REVISION A - DATE 19-06-2019

Project PROPOSED ADDITIONS & ATERAIONS 84 HILMA STREET COLLAROY PLATEAU

DA2019/0335

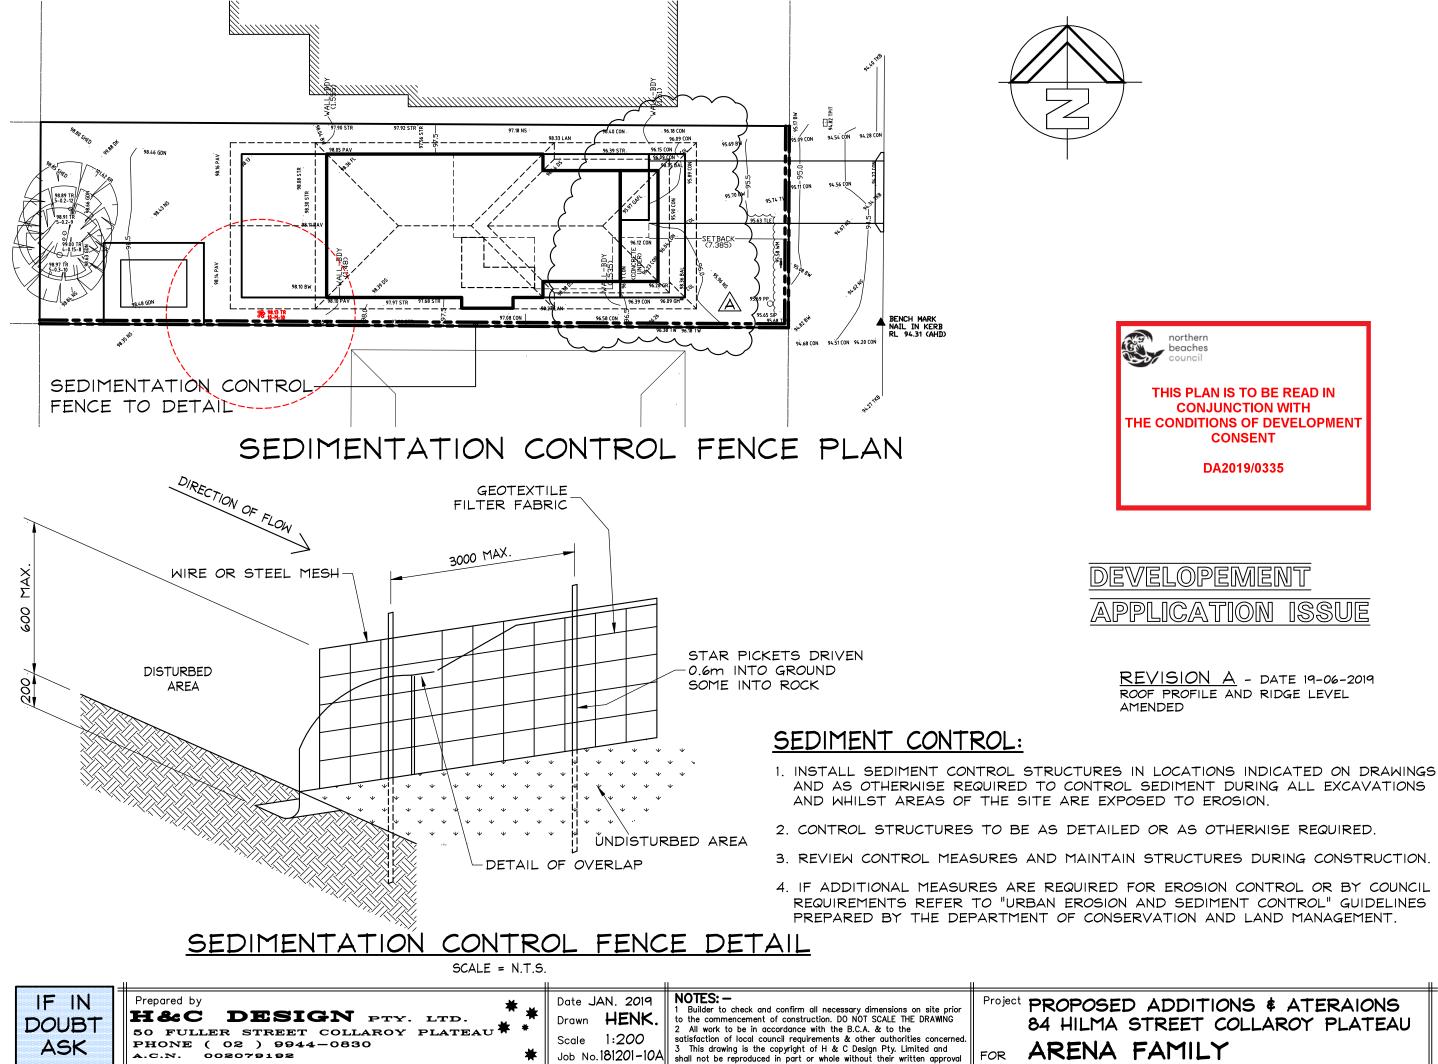
REVISION A - DATE 19-06-2019 ROOF PROFILE AND RIDGE LEVEL
